**LHC**

REFERENCE  
**LHC-TC-EC-0012**

## ENGINEERING CHANGE REQUEST

# Installation in IR2 of dispersion suppressor collimators (TCLD)

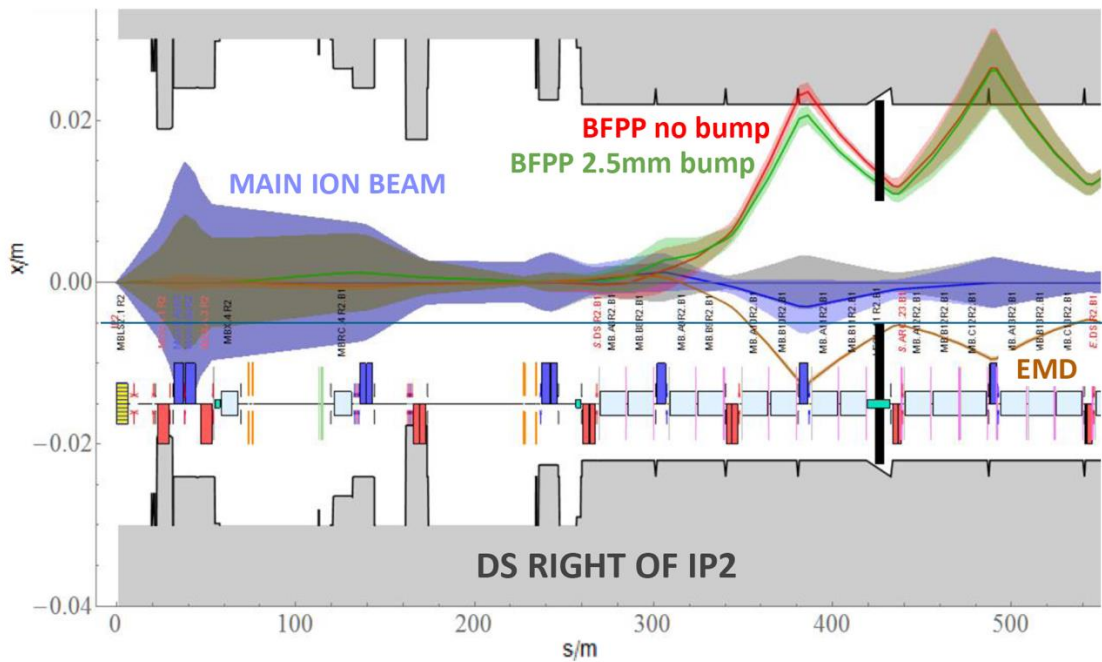
The magnets that are impacted by these losses are likely to quench at the high luminosities foreseen for HL-LHC. As alleviation, it is planned to install additional collimators (shown as black lines in Figure 1).

As can be seen in Figure 1, these secondary beams are lost very locally due to the large and sudden change of magnetic rigidity at the interaction point. After the LS2 ALICE upgrade, aiming at a peak luminosity of  $6 \times 10^{27} \text{cm}^{-2} \text{s}^{-1}$  (about six times higher than the nominal one) [3], the dominant BFPP1 beam can carry about 155 W, resulting in a

power load in the coils of the MB.B10 dipole of about  $44 \text{ mW/cm}^3$  [4] on both sides of ALICE. Similar ion losses also occur in the DS regions around ATLAS and CMS, however at different locations than in IR2. A beam loss experiment carried out during the 2015 Pb-Pb run at  $6.37 \text{ Z TeV}$  [5] confirmed the long-standing presumption that BFPP1 ions risk to quench magnets [1, 2]. The experiment was carried out around CMS because it was running at higher peak luminosity than ALICE. The deposited power during the quench was estimated with FLUKA simulations to be about a factor 6 lower than what is calculated for HL-LHC, hence this effect could be a serious limitation for HL-LHC.

During standard operation, special bumps were deployed around ATLAS and CMS to steer the BFPP1 losses into the locations of the connection cryostat, however, because of the quadrupole polarities in IR2, this solution alone is not possible at ALICE. Instead, the HL-LHC baseline is to install one additional collimator, called TCLD, on each outgoing beam in the IR2 dispersion suppressor, where the dispersion is already rising [3]. Orbit bumps allow making sure that the beam is not lost at the first (lower) dispersion peak (see Figure 1) and enable shifting the losses into the collimators. These TCLDs will also intercept the most powerful EMD beam (EMD1). FLUKA simulations have shown that the proposed TCLDs reduce the peak load on the magnets to tractable levels at HL-LHC design luminosity [4].

Figure 4 — 3D drawing of the TCLD jaws, integrated in the tank and installed on the supports. Courtesy of L. Gentini – SmarTeam number ST0676575.

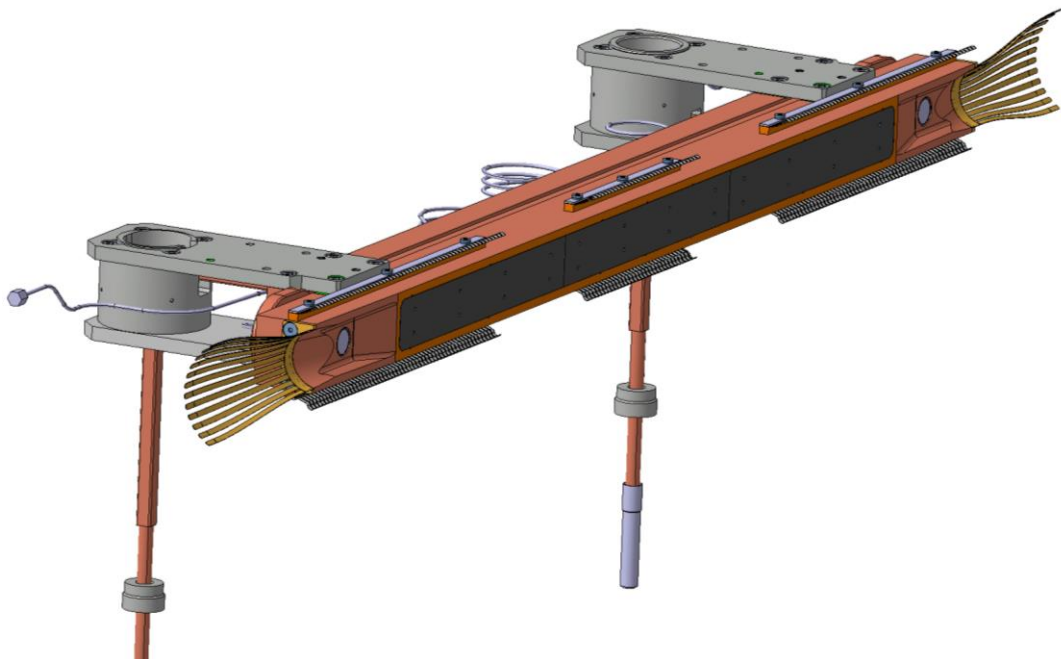
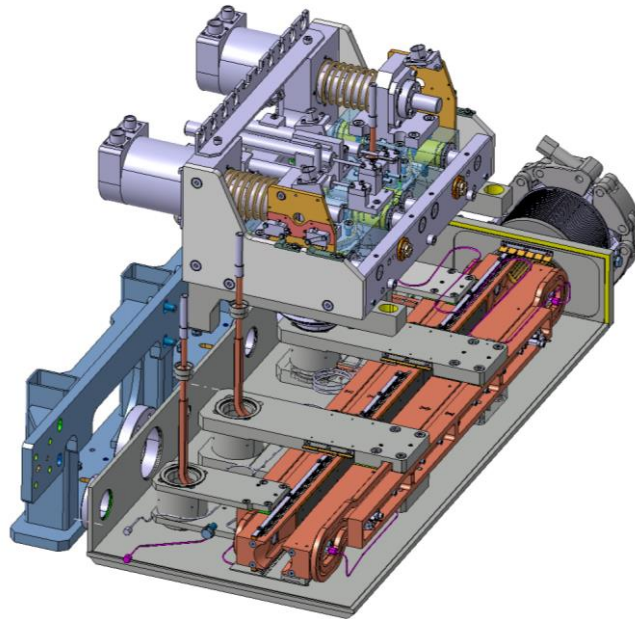
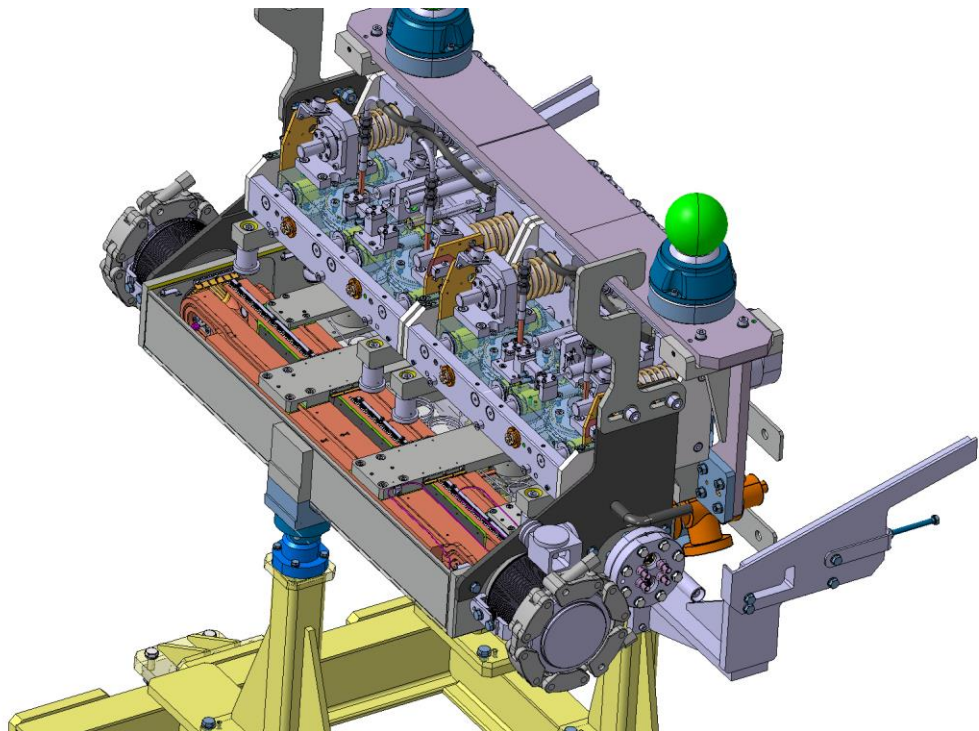
The TCLD consists, as most other LHC collimators, of two parallel jaws collimating the beam in the horizontal plane, with the beam passing in between them. The active material of the jaws is the tungsten alloy Inermet 180. The design of the TCLD collimator, shown in more detail in Figure 2, Figure 3 and Figure 4, is derived from the design of the present LHC collimators, but with some differences. Since the design of the IR2 TCLDs is identical to that of the IR7 ones, and because of the very tight space requirements in IR7, the design is challenging and the active length of the material had to be reduced to only 60 cm, in order to make it fit. This means that also a non-standard support design is used. Furthermore, the bellows at the two longitudinal extremities are integrated in the tank transitions in order to gain longitudinal space. Special tooling for transport, handling and for the retraction of the collimator bellows during the installation has been designed. In order to gain as much space around the TCLD vacuum tank as

Figure 5 – 3D drawing of the TCLD tank and support. Courtesy of L. Gentini – SmarTeam number ST0676575.

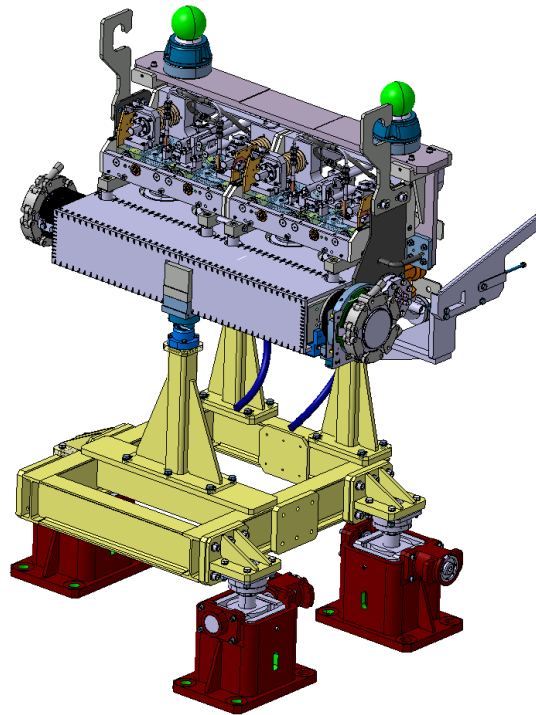
possible, a new thinner set of heating jackets (aerogel) has also been produced. A 3D drawing of the tank and support is shown in Figure 5.

Figure 6 – The assembly to be installed at the location of the IP2 connection cryostats, consisting of TCLD collimator, support, beam pipe for the other beam, and cryo-bypass. Courtesy of L. Gentini – SmarTeam number ST0676575.

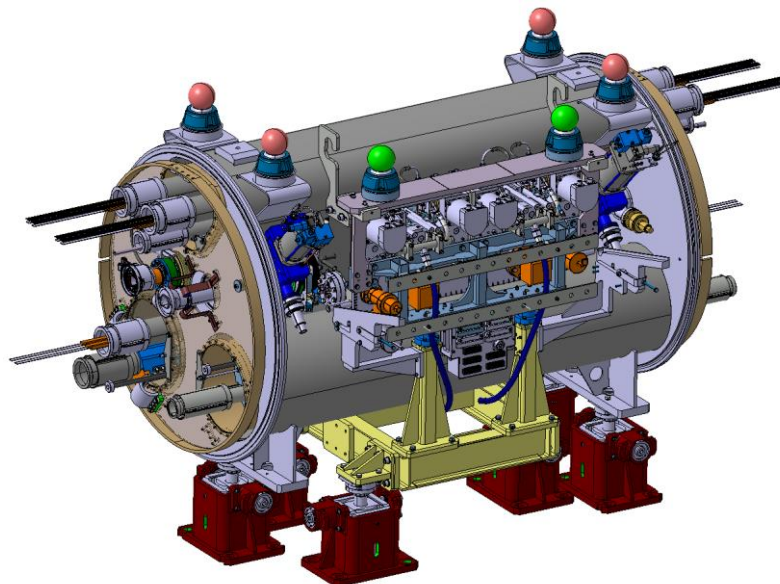
The TCLD will be integrated in a specially designed assembly, containing a beam pipe for the other beam, as well as a cryo-bypass, which is needed since the TCLD is a warm element placed between two cold ones. This assembly, which is discussed more in detail in a separate ECR, is shown in Figure 6.
